Relevant Information for Local Planning Panel

FILE: D/2023/790 **DATE:** 28 February 2024

SUBJECT: Information Relevant To Item 5 – Development Application: 56A Allen Street, Glebe – D/2023/790

SK-03

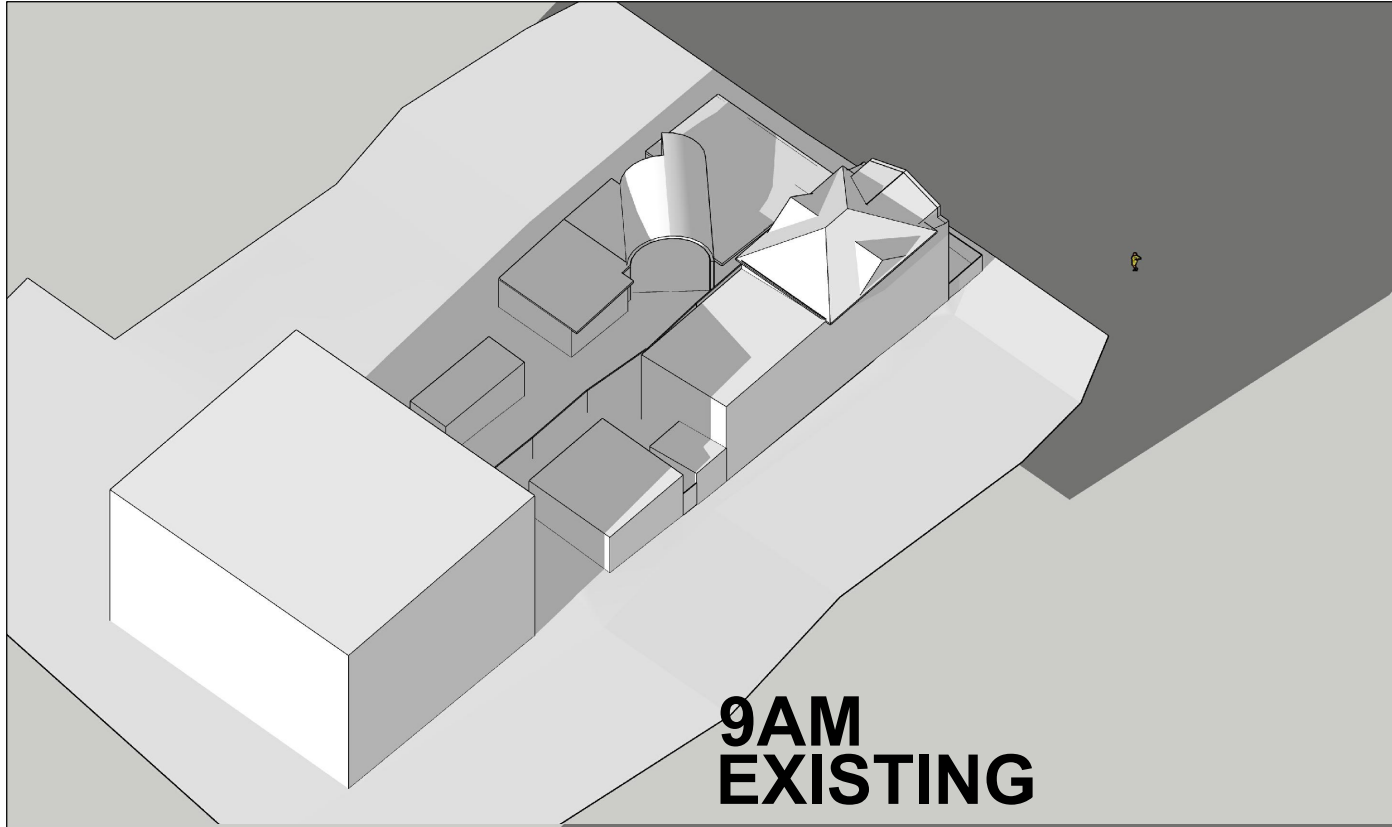
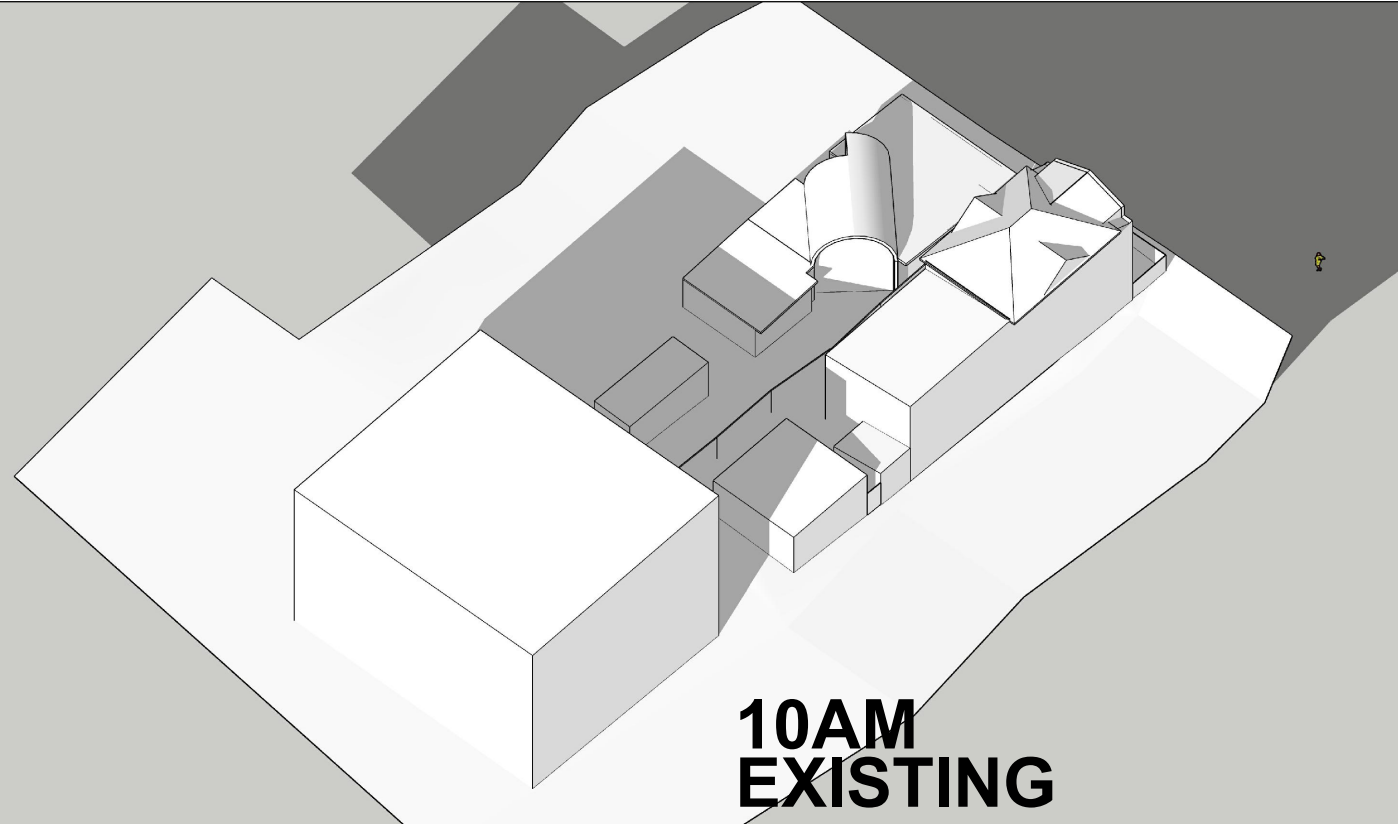
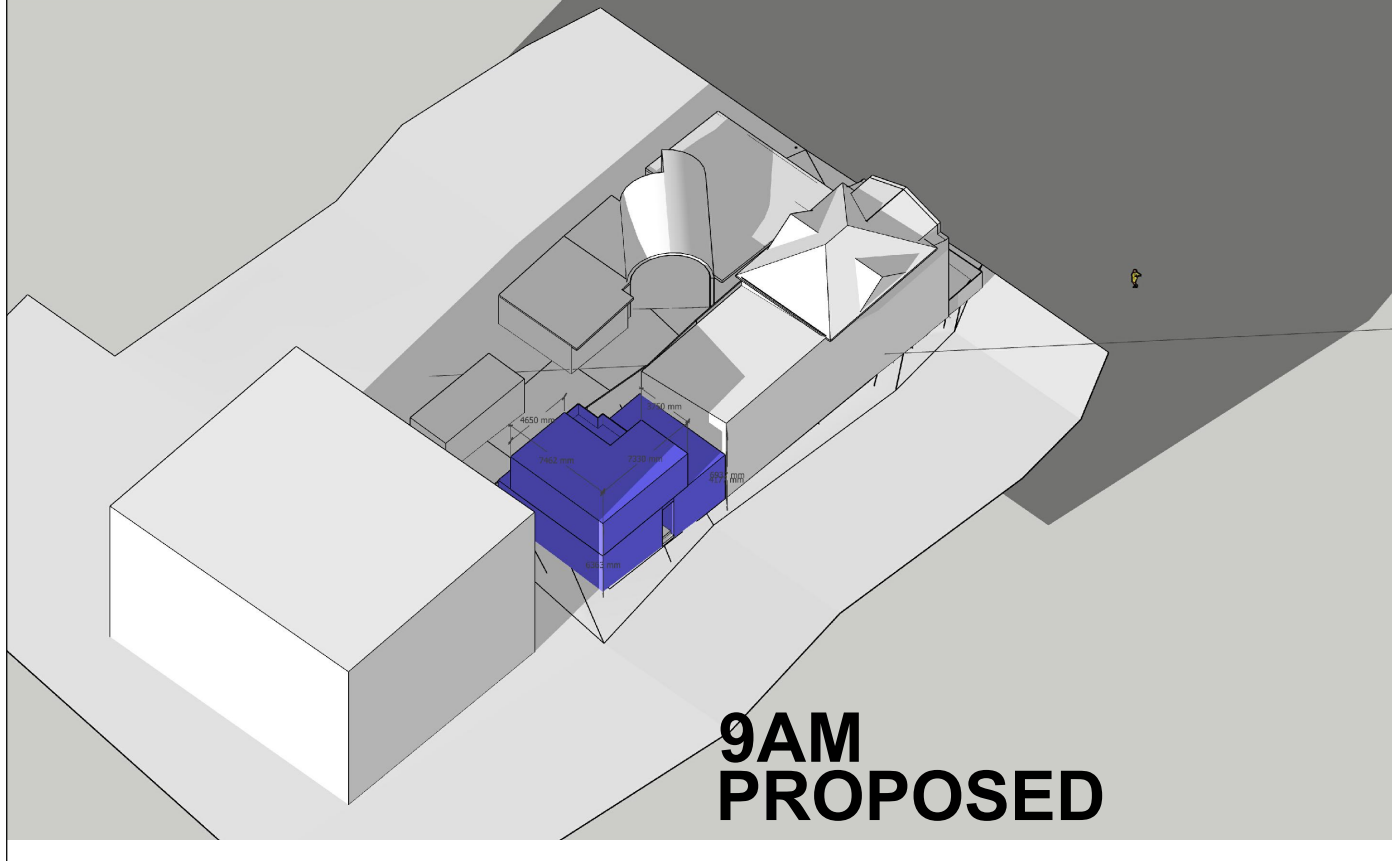
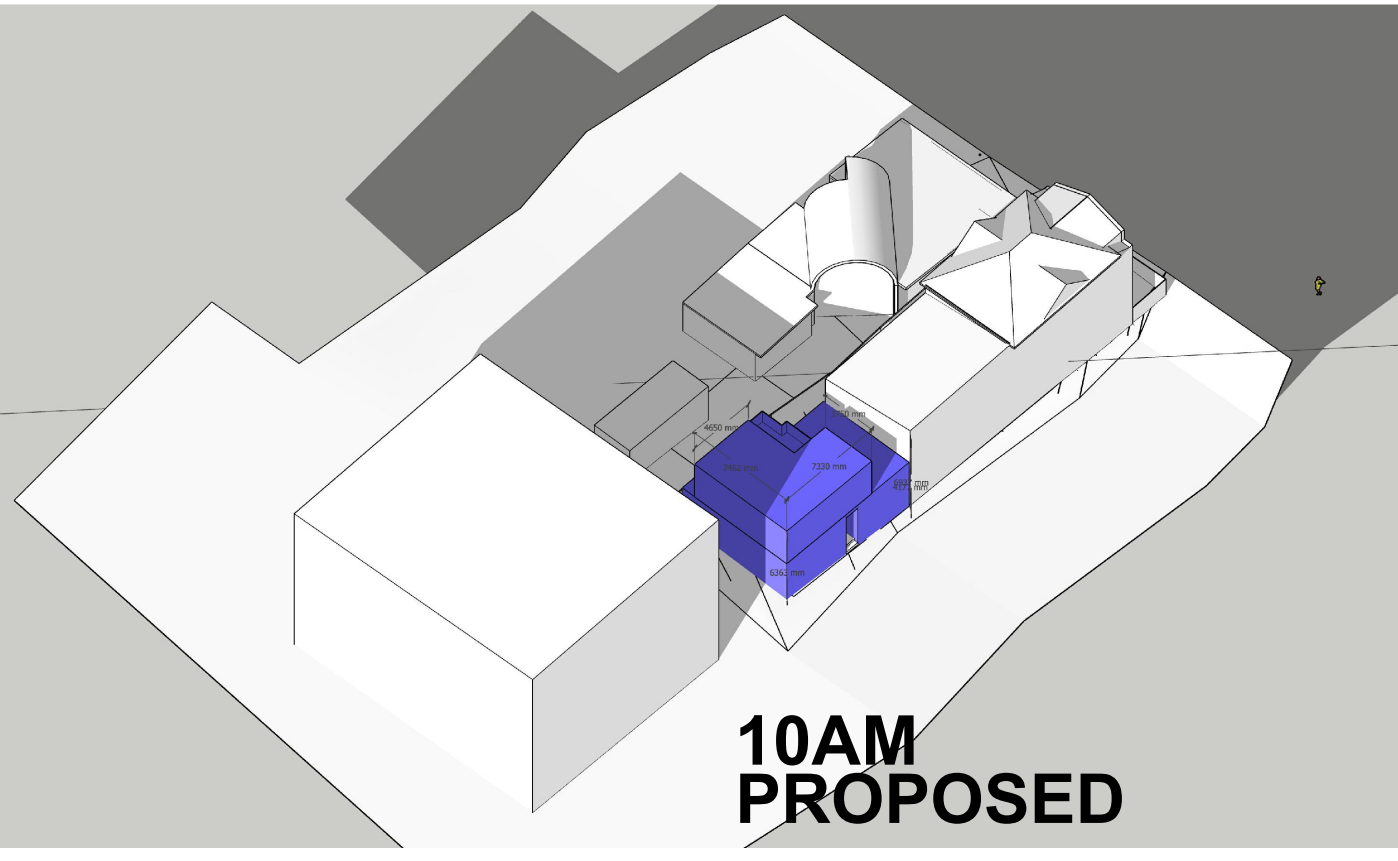
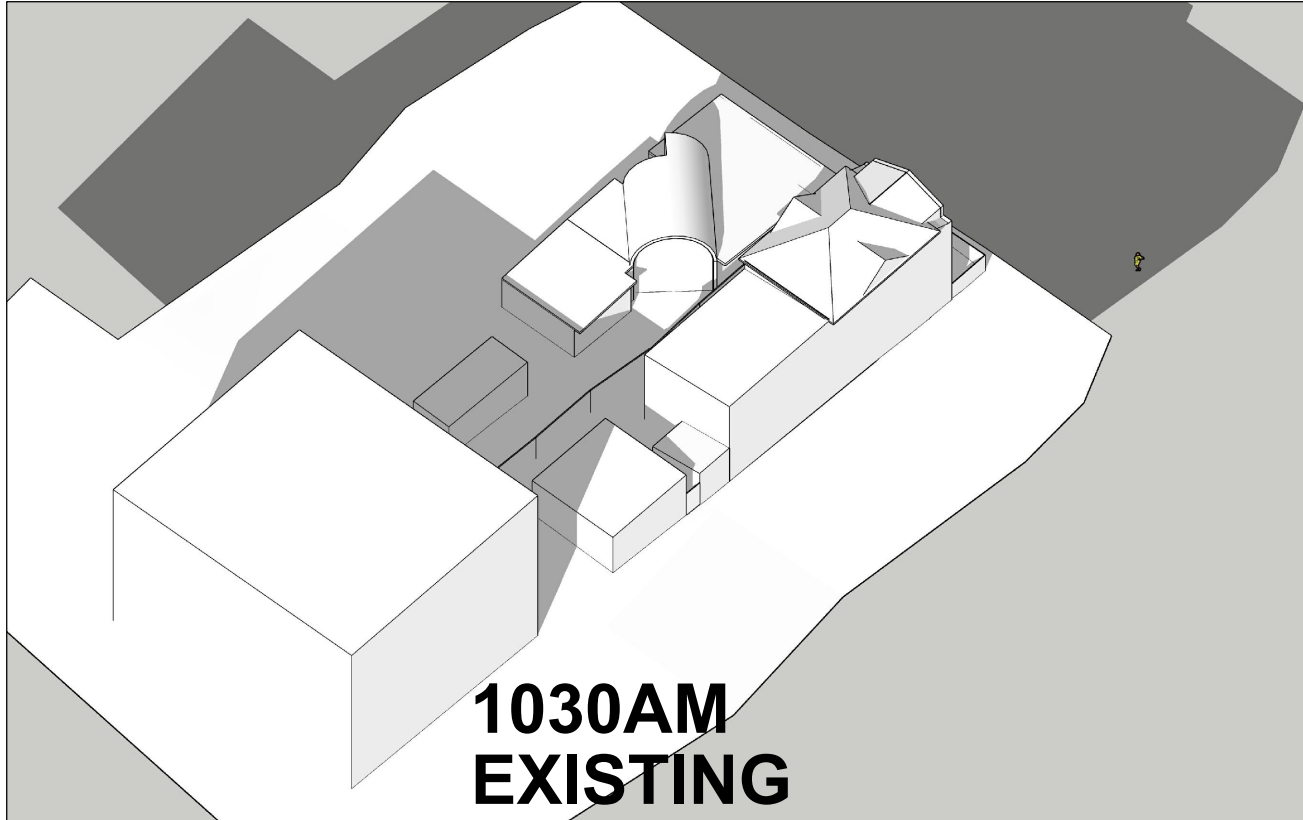
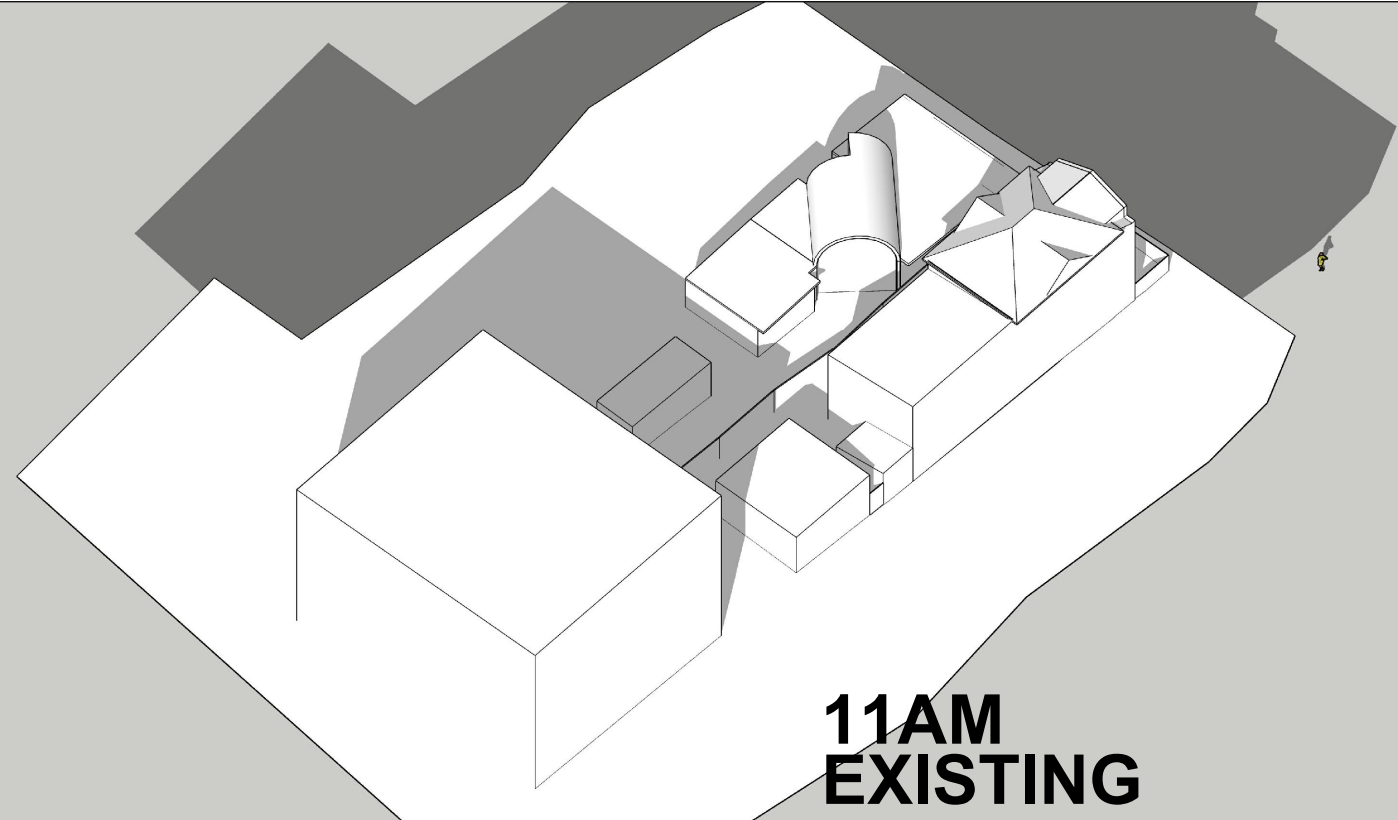
Shadow diagrams in elevation were submitted with the applicant's request, showing the shadow impacts between 9.00am and 12.00pm. However, 3.00pm shadow diagrams were not submitted. The shadow diagrams submitted with the request did not distinguish between the existing and proposed shadows, although it appeared that there would be an impact to the private open space of number 56 Allen Street to the south.

As discussed in the report the shadow diagrams are insufficient and do not clearly demonstrate solar access to the areas of private and common open space or living room windows for the subject site or neighbouring dwelling.

Shadow diagrams have been submitted with this proposal but are not adequate for assessment. They must clearly distinguish between the existing and proposed shadows. Although, there does appear to be shadowing impacts to the private open space of no. 56 and it may not meet the requirements of the SDCP 2012 controls. There is a development application currently under assessment for that site, so when a development application for the subject site is lodged it should demonstrate the impacts to the existing building, and the new building (if the DA is approved).
